SEOUOYAH NUCLEAR PLANT
ERCW CONDUIT SETTLEMENT MONITORING

Updated Results - December 1980

Figure Q2.86-6

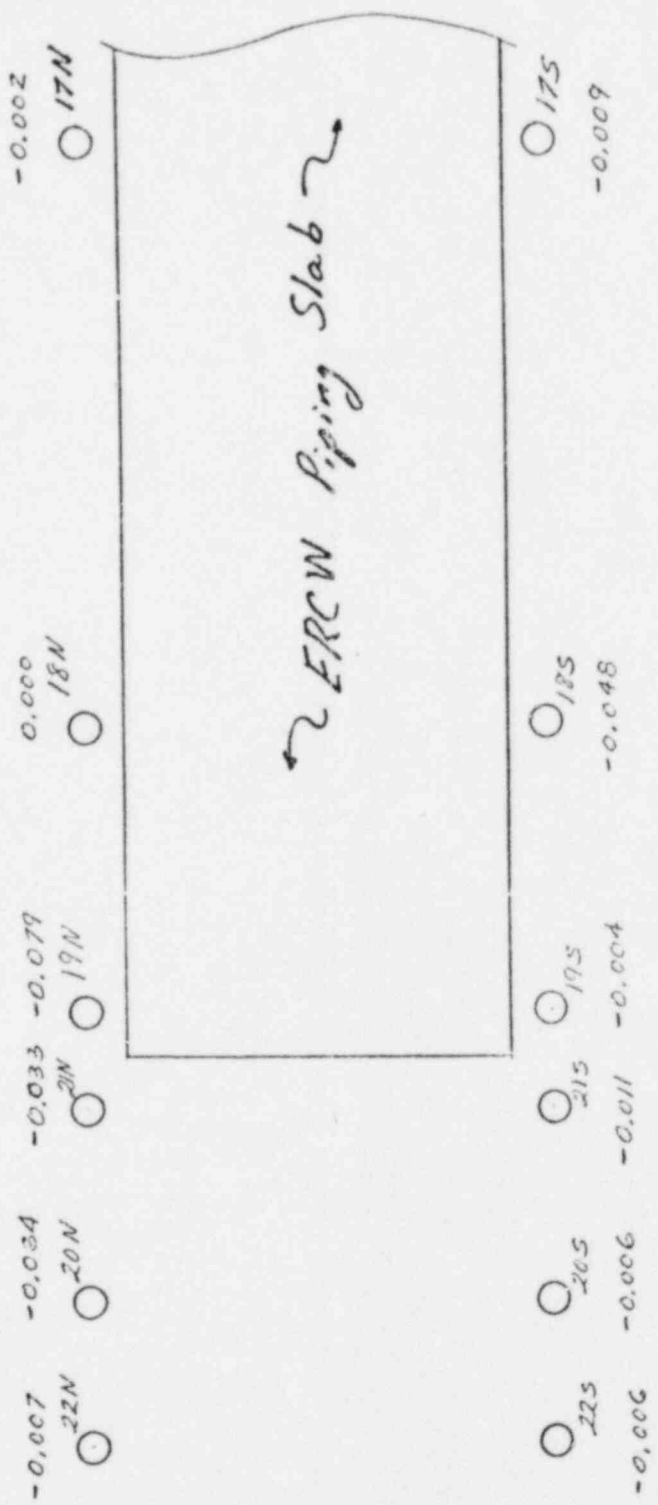
As discussed in our response to Q2.86, several settlement markers were hit during construction. This is documented in the survey notes. The surveyors reported markers as either "monument hit" or "monument possibly hit." These data are included in Table Q2.86-1. During the site visit October 27, 1980, the NRC representative, Raman Pichumani, viewed these markers. The distress to the markers, which are just rebars in a pipe sleeve, was visually very apparent. The procedure used to correct the actual survey data to account for marker disturbance is thus justified.

The apparent movement of the disturbed markers is not logically explained as just consolidation settlement. For example, the markers were reported as hit on the December 19, 1979, survey. No settlement trend existed based on the previous data. Variations are only a few thousandths of a foot on monthly reading for four months. In fact some of the readings show an upward not downward movement (19N & 20N). The markers were reported hit with the December 19, 1979, reading. "Movements" of up to - 0.079 feet (down) are reported. However, movement from December 19, 1979, to present show no settlement trend. Variations are again a few thousandths on monthly readings for four months. Such a sudden jump in settlement with no pre- or post- activity is not logically explained by any consolidation theory.

Also, the reported "movements" are not logical when viewed in plan. Markers are present on each side of the road (road width is 20 feet, approximate marker separation is 25 feet) and at 30-foot intervals along the road. Figure Q2.84-6 shows an enlargement of the area between markers 17 and 22, the area of interest. The data shown are for the December 19, 1979, the reported hit date. The largest "movement" is reported for #19N (-0.079 ft.). However, #18N (30 feet east) reports 0.0 ft., #19S (25 feet south) reports -0.004 feet, #20N (30 feet west) reports -0.034 (also reported as hit), and #21N (10 feet west) reports -0.033 (also reported as hit). The second largest "movement" is reported for #18S (-0.048 feet). Adjacent markers #17S (30 feet east) reports -0.009 feet, #19S (30 feet west) reports -0.004 feet, #18N (25 feet north) reports 0.0 feet. In addition, the road and curbing show no signs of distress in the vicinity of these markers. Such local pockets of settlement might be explained by consolidation. However, consolidation cannot explain that they appear in one month with no pre- or post- activity and cannot explain the lack of impact on the road.

Nevertheless, even if the 0.079 feet of settlement is valid and should be considered, it has no adverse effect on the pipes. The 36-inch diameter ERCW pipes are protected by a 60-foot long steel 42-inch diameter steel pipe sleeve as it crosses from the pile supported slab to insitu soil. The pipe sleeve extends from 20 feet back along the slab to 40 feet beyond the end of the slab. Details of the pipe sleeve are shown in figure Q2.71-5. The ERCW pipes as sleeved will withstand settlements of six inches and be within allowable limits. This is as discussed in our response to Question 2.72.
